Re: Utility Scale Solar Application -- Cricket Solar, LLC

The Piedmont Environmental Council (PEC) respectfully submits this letter to address the Utility Scale Solar Application - Cricket Solar, LLC, submitted to the Culpeper County Department of Development on December 21, 2018.

RECOMMENDATIONS/CONSIDERATIONS FOR CRICKET SOLAR, LLC (PROJECT) APPLICATION

Cricket Solar Proposal

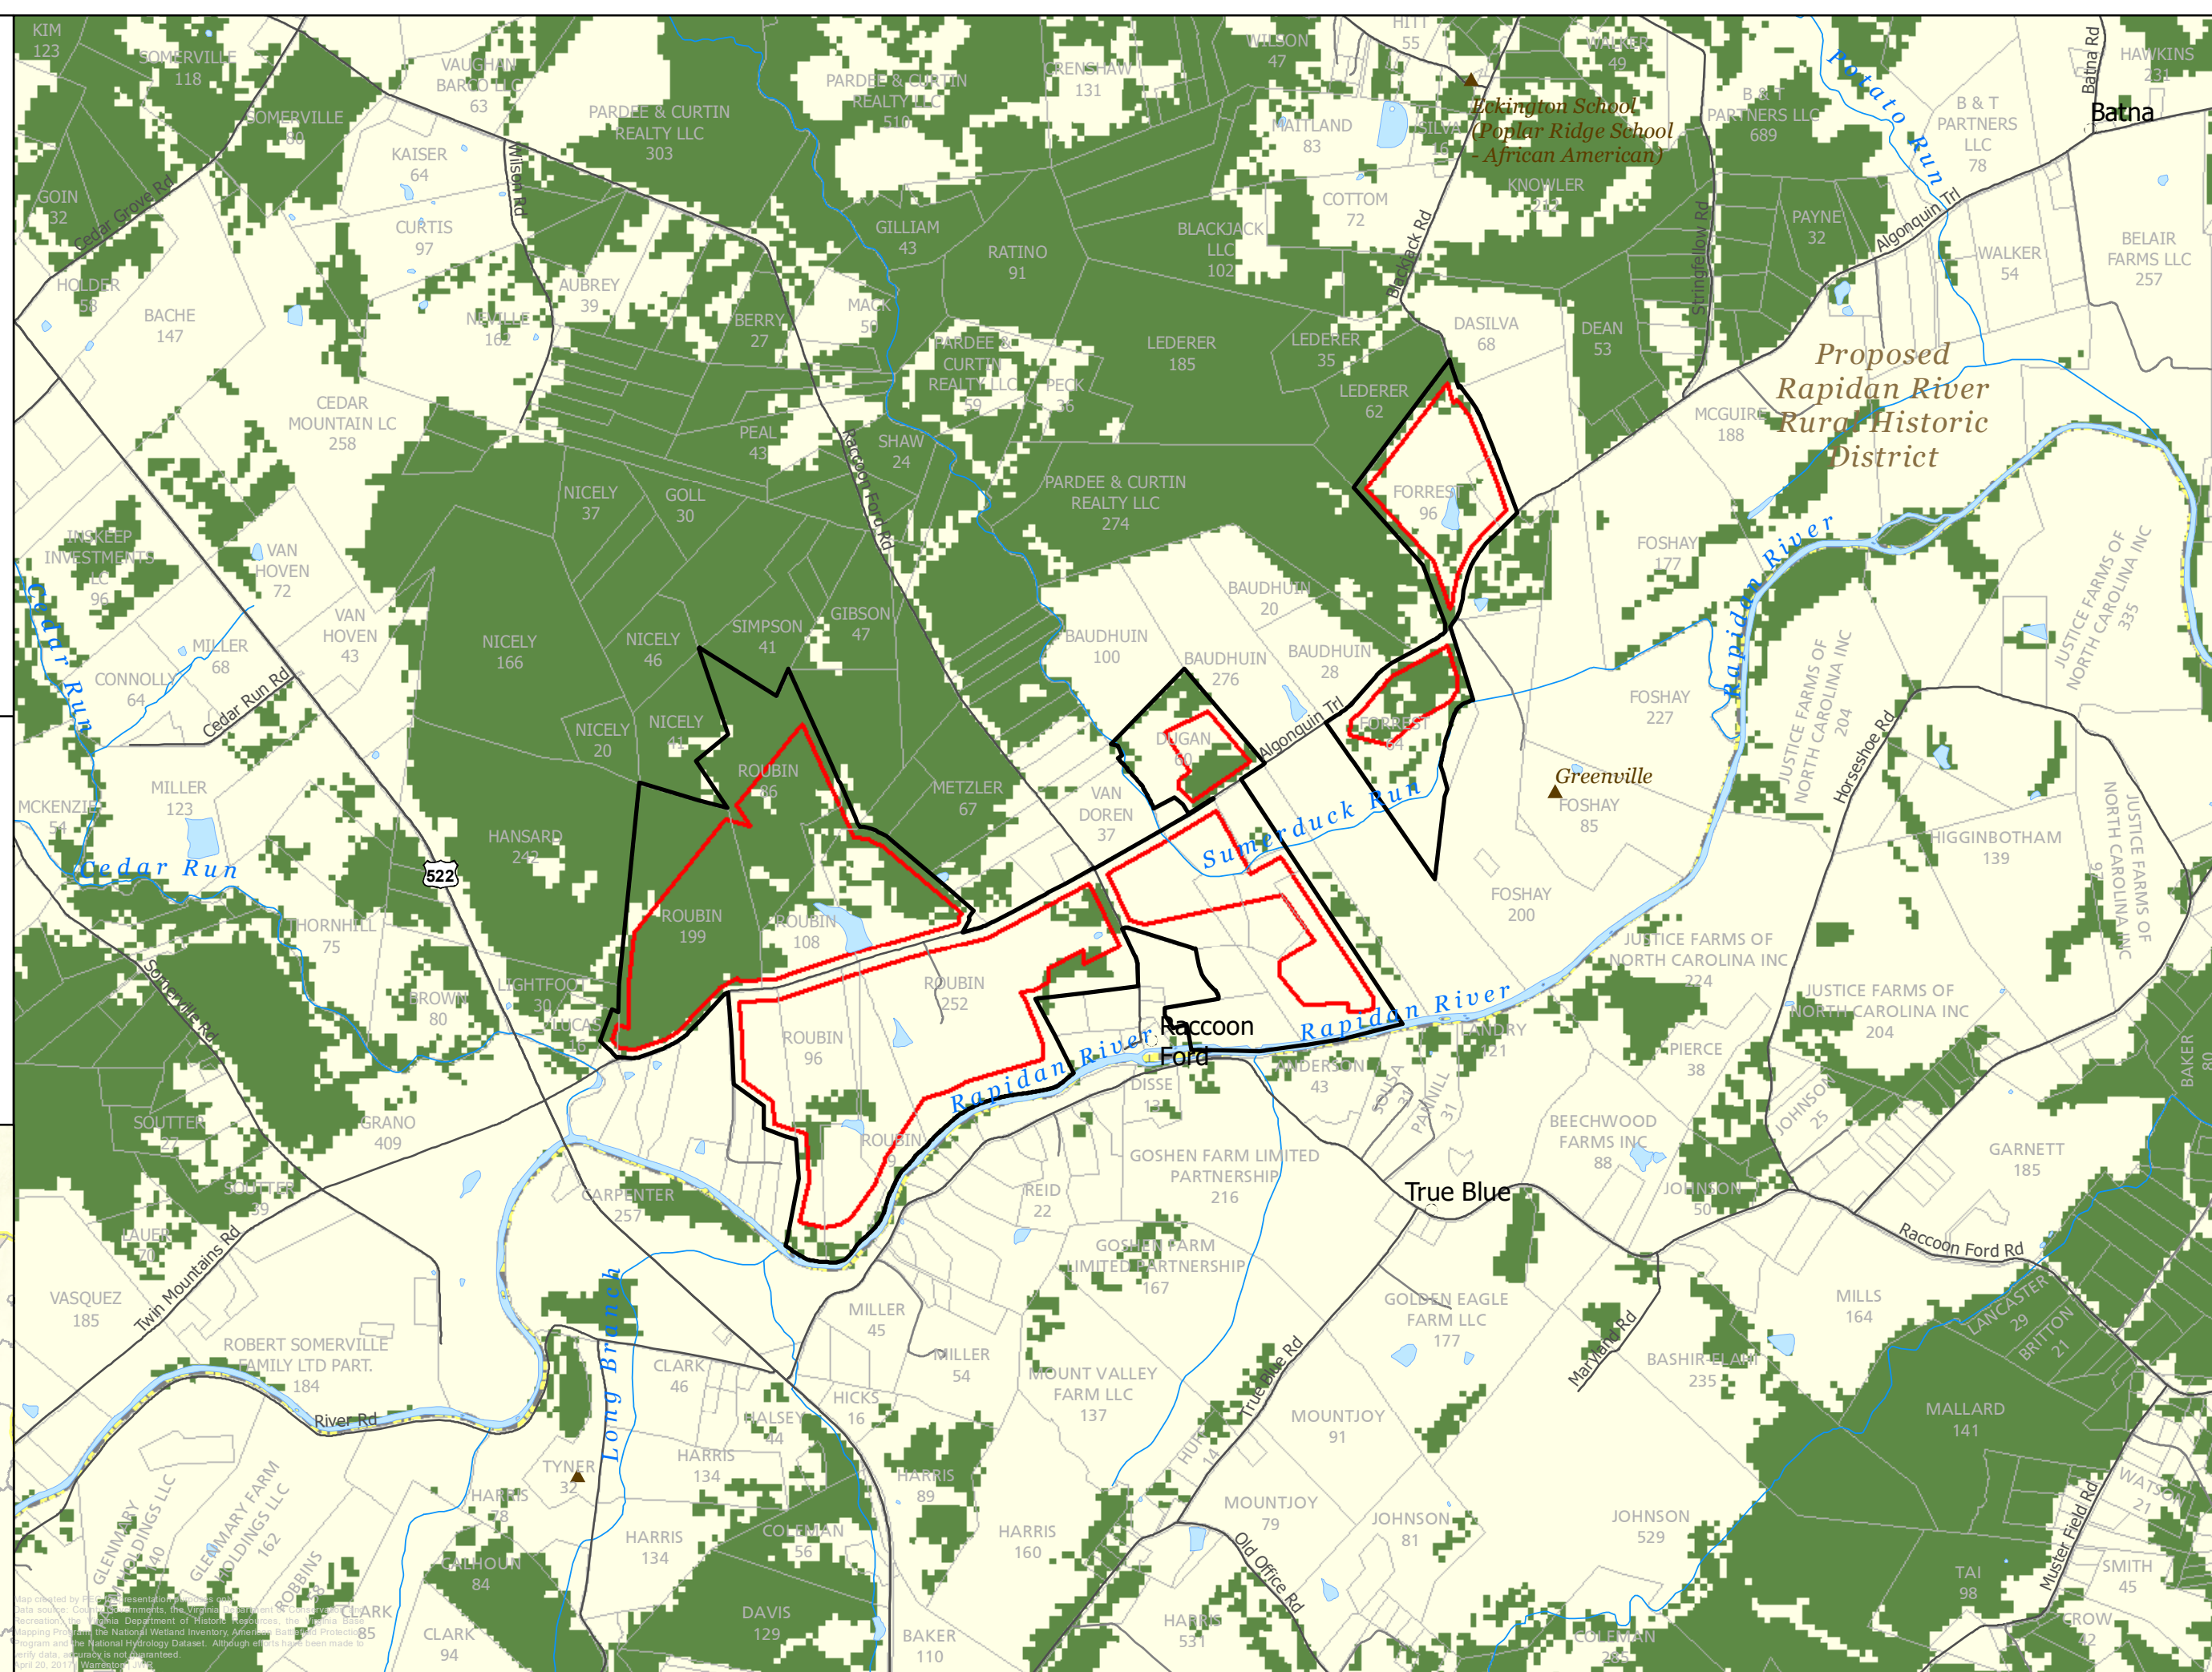
- The total Project area will directly impact 404-acres of forested land, including the fenced in portion of the Project.
- The fenced in portion of the Project will directly impact forests classified by the Department of Forestry (DOF) as "Forests of Conservation Value", specifically the following conservation value classifications and associated acreage amounts:
 - Low 21.3 acres
 - Medium 54.5 acres
 - High 141.2 acres
 - Very High 30.0
 - **Total 247.0 acres**

Additionally, PEC does not support replacing forested land, especially hardwoods and those classified by the DOF as being high in “forest conservation value”, with solar panels. Although PEC supports solar power as a viable reusable energy source, solar power does not outway the value of replacing natural resources (i.e. 247-acres of forested land) that act as “carbon sinks”.

Natural and historic resources impacted by the Project are depicted on the attached Figures.
